474.

## Galloper crank failure

Figure 5  
New clamp design

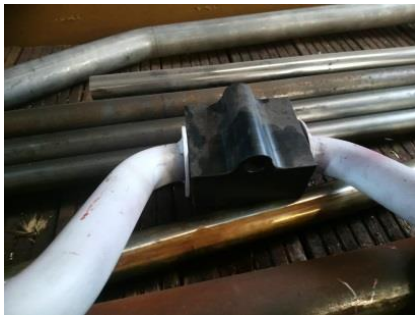
The crank design incorporated welded washers on either side of the horse pole bearing to keep the bearing in position during operation.

The failure occurred directly under the bearing side washer. It is understood that the cranks had been subjected to annual inspection, but due to the washer being welded to the crank the critical area directly under the washer cannot be subjected to inspection. The manufacturer has been contacted and informed of this failure/design issue.

Following their investigation into the cause of the failure, the manufacturer has redesigned the way the bearing is held in position by using clamps (image 5) either side of the bearing instead of the welded washer to retain the bearing in position.

As this is a change to the original design this modification should be subjected to pre-use inspections.
